# Q1 How well do you feel the North Campus initial site layout concept screens views of the future filtration facility?

## Q2 What are your top three likes or dislikes for the 'North Campus' site layout concept?

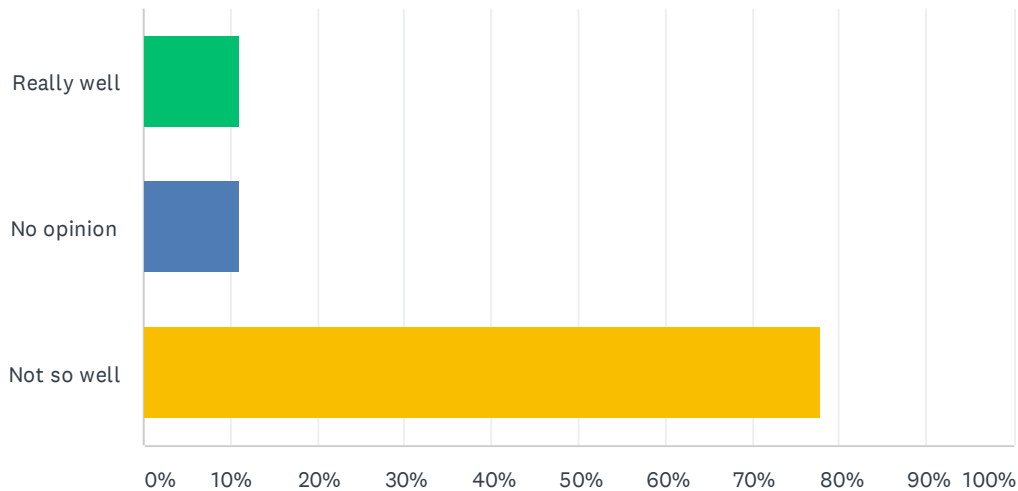
#	MORE TO ADD?	DATE
1	They both look about the same from the Carpenter Lane view.	8/11/2020 6:11 PM
2	Not really much difference between 2 alternatives	8/11/2020 6:09 PM
3	The tower is oppressive	8/11/2020 5:02 PM
4	Why stick the communication tower in such a place as to block potential view? ....and not include it on the South version? Why the close proximation of the chemical building to the Ozone and Electrical Buildings? After Recent events in Lebanon, I would have thought storage, fire potential and electrical back-up would best be served at a distance.	8/11/2020 2:36 PM
5	I do prefer this option, but I am unclear what the advantages are for each option. Is it best to have covered filters?	8/11/2020 10:20 AM
6	I believe the view from the west can be shielded more.	8/10/2020 6:31 PM

#	#1	DATE
1	The Carpenter Lane entrance in this view is further West which is better for the Kost's home.	8/11/2020 6:11 PM
2	(-) More spread out	8/11/2020 6:09 PM
3	tower	8/11/2020 5:02 PM
4	DISLIKE - Relies too heavily on North access road via Carpenter Lane	8/11/2020 2:36 PM
5	I like the abundance of trees being implemented/used to cover the site.	8/10/2020 6:31 PM
6	Tower	8/10/2020 12:16 PM
7	We do not like the possibility of a paved road behind our property shown on North Campus view	8/5/2020 10:34 AM
8	Need more trees looking West	8/3/2020 7:10 AM

#	#2	DATE
1	The road that goes along the east side of property looks like it will be too close to the neighbors on that side.	8/11/2020 6:11 PM
2	(-) Not quite as much room for agriculture	8/11/2020 6:09 PM
3	Tower	8/11/2020 5:02 PM
4	LIKE - Covered filtration units	8/11/2020 2:36 PM
5	I wish there was more covered looking north from Bluff, as that is where the school is.	8/10/2020 6:31 PM
6	No ponds at carpenter lane	8/10/2020 12:16 PM
7	Would potential communications tower benefit neighbors as well?	8/5/2020 10:34 AM
8	South from Carpenter looks good	8/3/2020 7:10 AM

#	#3	DATE
1	I prefer irregular shaped ponds over the square ones.	8/11/2020 6:11 PM
2	DISLIKE - Incorporates use of eastern lot without option for including agriculture. The east to south road follows too closely to residences and school.	8/11/2020 2:36 PM

## Q4 How well do you feel the 'South Campus' initial site layout concept screens views of the future filtration facility?

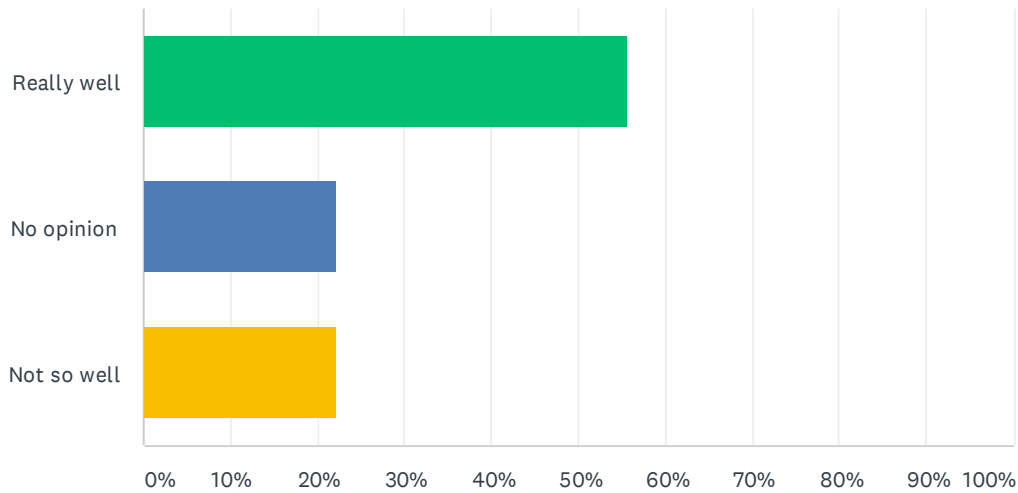
#	RESPONSES	DATE
1	Move the driveway further west.	8/11/2020 6:11 PM
2	Remove spur paved stub road east of main campus	8/11/2020 6:09 PM
3	the tower and how it blocks the mountain view	8/11/2020 5:02 PM
4	South access road design/location.	8/11/2020 2:36 PM
5	I need more information. What is the "potential communications tower" and why is it set so far to the East?	8/11/2020 10:20 AM
6	How prominent the the large tower is from all angles.	8/10/2020 6:31 PM
7	Tower.	8/10/2020 12:16 PM
8	No paved road behind Walter's property.	8/5/2020 10:34 AM

#	MORE TO ADD?	DATE
1	Again, they look like they are similar.	8/11/2020 6:11 PM
2	I like this a bit more than the North Campus--but there doesn't seem to be much difference	8/11/2020 6:09 PM
3	Why enclosed filters on North Campus, but not on South Campus? And did you confuse the looking west and east diagrams?	8/11/2020 2:36 PM
4	I do like it being more compact but I don't want taller buildings. It would be helpful if the advantages and disadvantages were covered at our next meeting. I don't see the tower in the South images. Why?	8/11/2020 10:20 AM
5	Realize this is initial information so need more in the future regarding trees, shrubs, etc.	8/5/2020 10:34 AM

#	#1	DATE
1	The North entrance appears to be right in front of our home on Carpenter Lane.	8/11/2020 6:11 PM
2	(+) Buildings are denser, so not more open space preserved	8/11/2020 6:09 PM
3	less mountain obstruction	8/11/2020 5:02 PM
4	LIKE - More reliant on access from Bluff Road and far enough from school	8/11/2020 2:36 PM
5	I enjoy how covered the site is through trees, etc.	8/10/2020 6:31 PM
6	Need Trees Looking East.	8/10/2020 12:16 PM
7	Like the idea of property for possible agricultural use with an 8 ft. fence to keep deer and elk out.	8/5/2020 10:34 AM
8	I like all of it.	8/3/2020 7:10 AM

#	#2	DATE
1	The ponds are too close to Carpenter Lane.	8/11/2020 6:11 PM
2	(+) Seems to have more area for agriculture	8/11/2020 6:09 PM
3	LIKE - Set back further from Dodge Park bluff/hillside.	8/11/2020 2:36 PM
4	Allowing for potential community use along site edges. Walking path?	8/5/2020 10:34 AM

#	#3	DATE
1	We would like the trees to obscure the plant but not our view beyond it.	8/11/2020 6:11 PM
2	DISLIKE - Proximity of Chemical building to Admin and Maintenance buildings.	8/11/2020 2:36 PM
3	South campus ground level perspective instead of "looking NE from neighbors" we think you meant "looking NW from neighbors" on page 25.	8/5/2020 10:34 AM
